Certificate of Appropriateness

Property 133 W. PITTSBURGH AV. South Second Street HD
Description of work Install black fabric awnings on ground level storefronts per attached drawings (projection from building may be reduced from that shown below at applicant's discretion). Alter ground floor storefronts and window spacing to accommodate unexpected structural issues. See extended narrative on following pages.
Date issued 7/14/2017 PTS ID 114316 COA: ground floor alterations and canopies

Detailed project narrative for elevation changes

NORTH ELEVATION

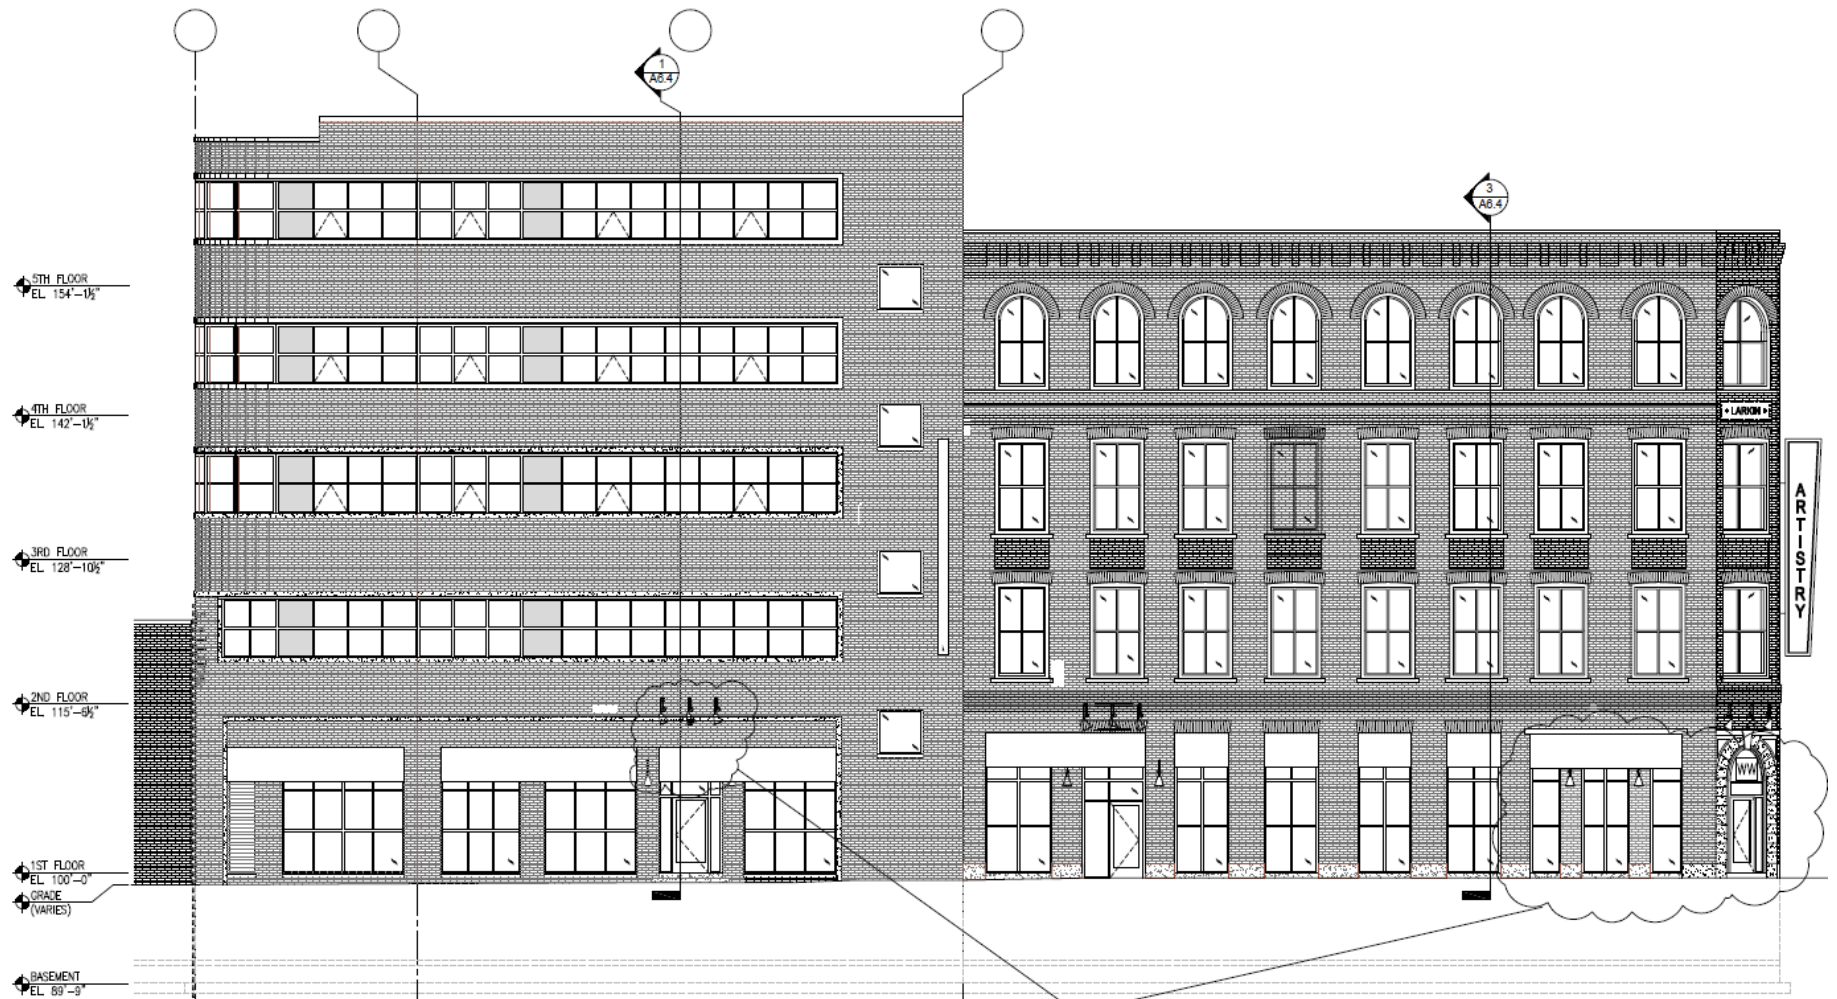
1. North elevation 4 story building - level 1- slight variations in column pier widths / window sizes as the result of existing structure and or structural repairs needed in the field.

1. ADJUSTED SPACING BETWEEN BRICK PILASTERS AND STOREFRONT TO WORK WITH FIELD CONDITIONS - STEEL LOCATED WITHIN THE WALL CAVITY
2. CORNER DOOR- MODIFIED STOOP / STEP FROM 1 STEP TO 2 STEPS TO WORK WITH EXISTING GRADE AND FLOOR ELEVATION CONDITIONS
3. LIGHTS ABOVE ENTRY- SHIFTED LIGHTS OVER CENTER OF ENTRANCE DOOR LOCATION.

SOUTH ELEVATION

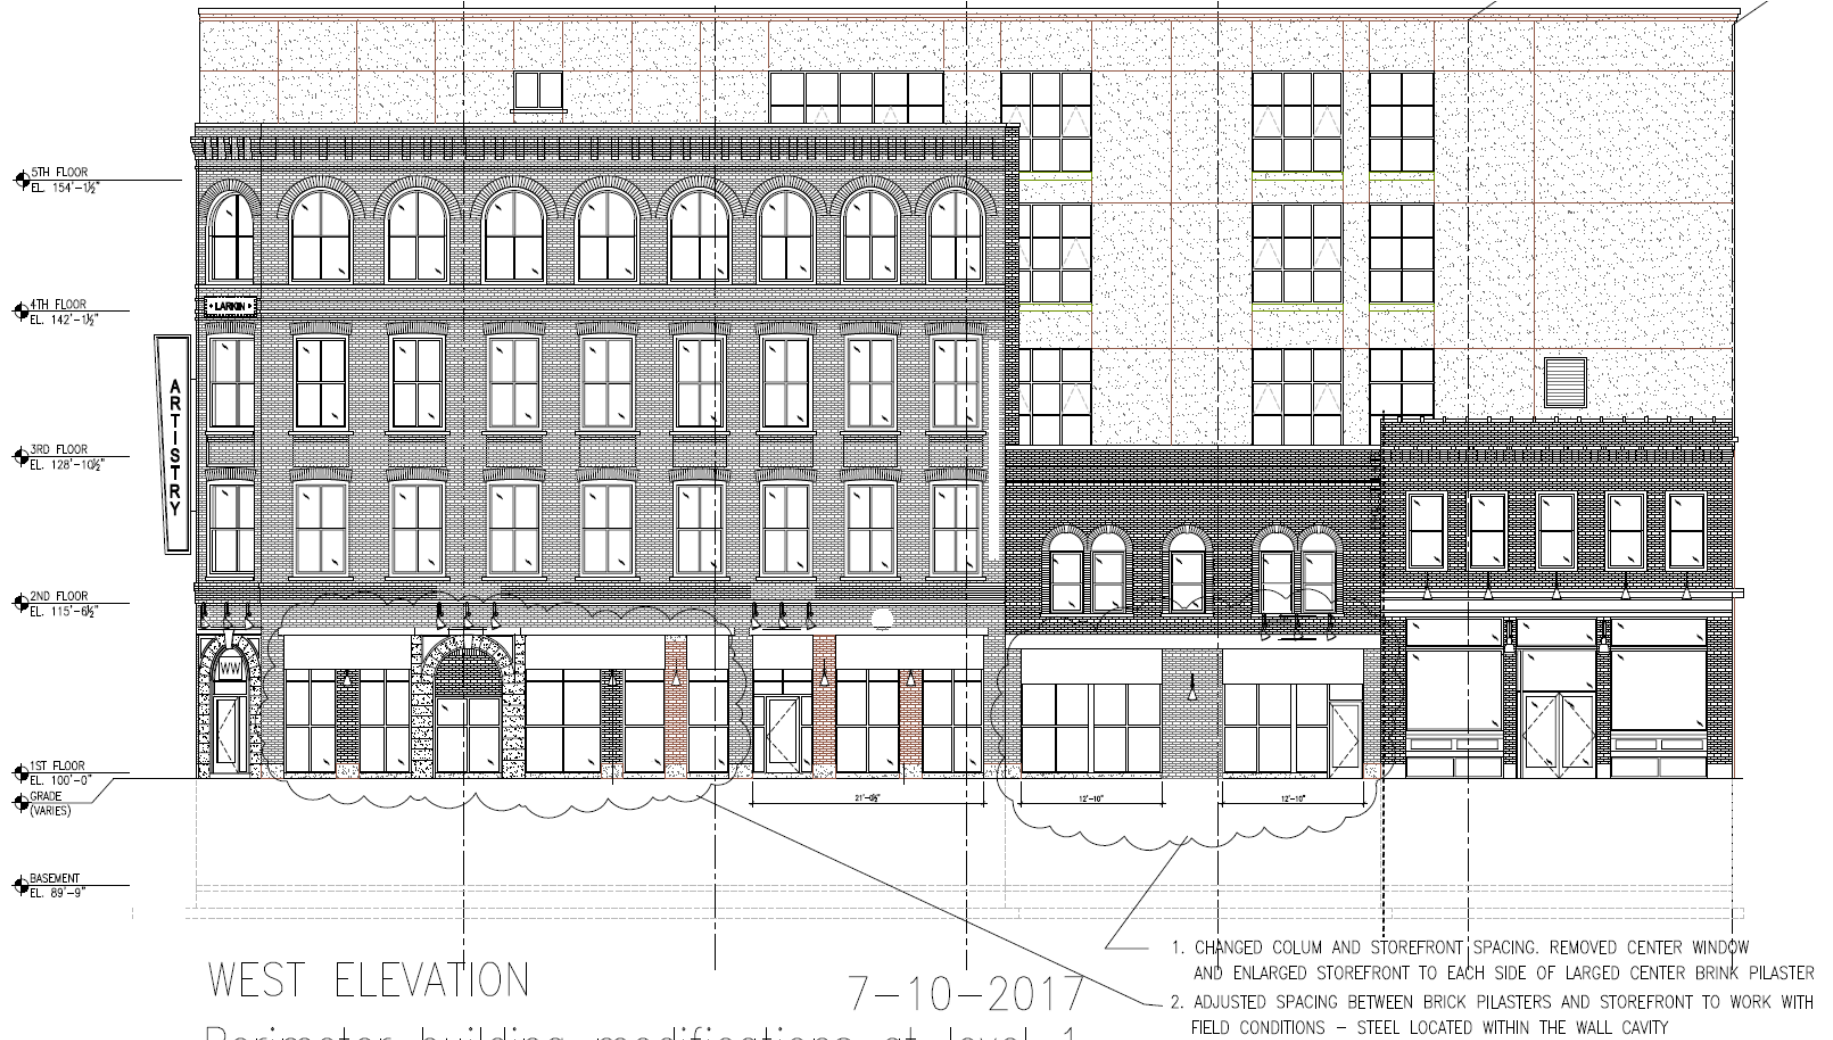
4. South elevation: building entrance.
the desire is to remove the overhead door to the east of the current recessed entrance and expand the width of the entrance opening. This will provide greater visibility and safety at the alley entrance for patrons who are coming and going from the south parking lot. the wider recessed alcove also allows for the stair door to move from the South face to the East face under the building overhang - creating a safer exiting condition and providing patrons with a view of the alley prior to stepping out into potential on-coming traffic. the impact visually to the building is minimal as the openings are within the previous loading dock zone and remain aligned with the existing facade fenestration.
